Office Action Summary	Application No. 10/551,852	Applicant(s) DALTON ET AL.	
	Examiner Evan Dzierzynski	Art Unit 2875

DETAILED ACTION

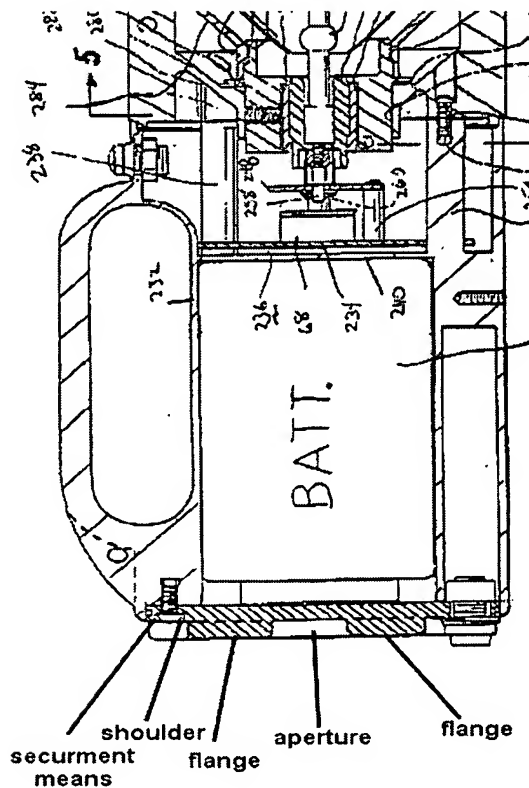
As for claim 31, a flashlight housing 232 defining an electrical contact aperture (where 88 connects to the housing) opening therethrough, a flashlight contact 312 for electrical connection of the flashlight to a power source, external to the flashlight the flashlight contact extending from inside the housing through the aperture and being disposed at least partly outside the flashlight housing (Fig 1b, bottom of Fig 4) and including a flange located outside of the housing that provides a shoulder adjacent the housing (as indicated below); a contact connection means (portion of shoulder protruding from bottom of housing, Fig 1a) for connecting the flashlight electrical contact to the flashlight housing. Jigamian also teaches a securement means (as indicated

below) securing the contact connection means in relation to the flashlight housing such that the shoulder maintains the sealing means under compression.
